## ZONING CHANGE REVIEW SHEET

CASE: C814-2008-0165.01  
(East Riverside PUD Amendment #1)

ADDRESS: 222 E. Riverside Drive

\*The applicant is requesting a PUD amendment for an increase in height from 96 feet to 200 feet on Tract 1 to allow for a multifamily project with more units on the property (*Please see Applicant's Request Letter – Exhibit C*).

EXHIBIT D

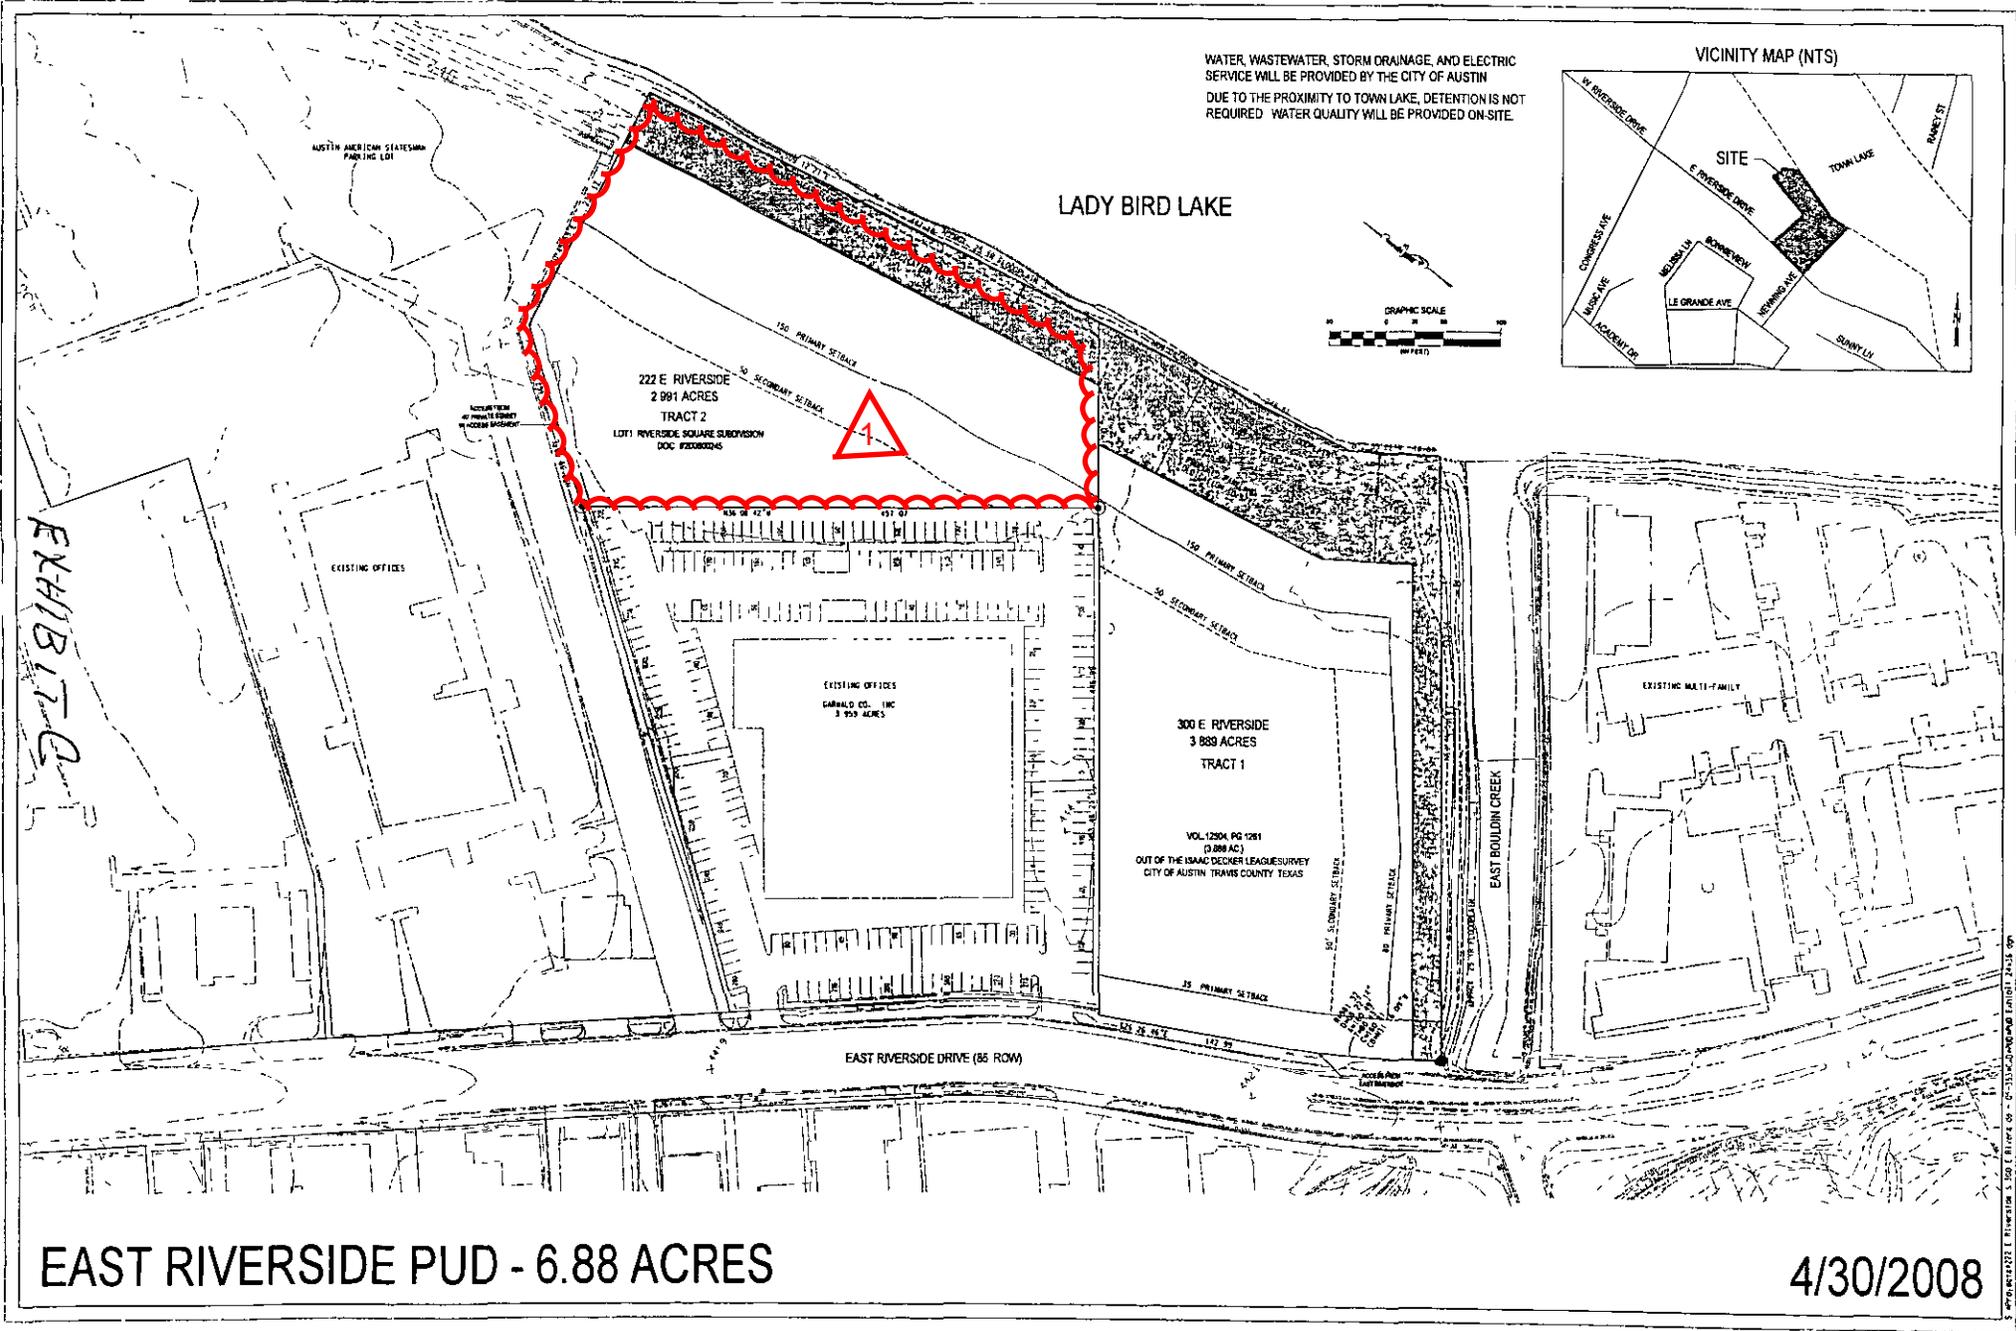
Per Robert, the following language change is requested on sheet 6:

Landowner shall construct at Landowner's expense a public reclaimed water system main extension from the adjacent property reclaimed water main. The reclaimed water main must either be extended from an adjoining reclaimed water main at the time of construction or capped at each end for future connection to a reclaimed water main by others. The public reclaimed water system main shall be temporarily connected to a public potable water main unless a serviceable reclaimed water main is available to the project. Total off-site construction of reclaimed water main shall not exceed 500 linear feet. The PUD shall be required to install a reclaimed water service and meters and connect to and utilize reclaimed water systems (purple pipe) for all irrigation, cooling, and toilet/urinal flushing uses in the PUD ~~when the extension is operational~~.
